Appl. No. 10/767,599
Amdt. dated Apr 18, 2005
Reply to Office action of Mar 24, 2005

Amendments to the Drawings:

REMARKS/ARGUMENTS

FIG 2

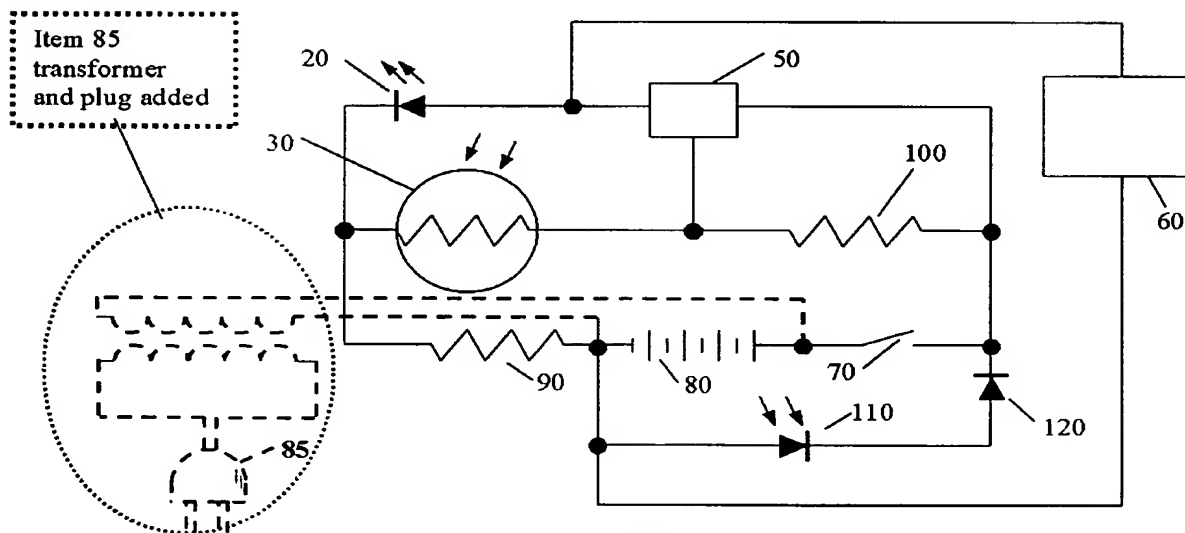
The attached sheet of drawings includes changes to Fig. 2. This sheet, which includes Fig. 1-2, replaces the original sheet including Fig. 1-2. In Figure 2, item 85 all outlet plug has been added.

Figure 2 was modified to show the external power plug. This was performed by including item 85 in the figure and was supported in the claims.
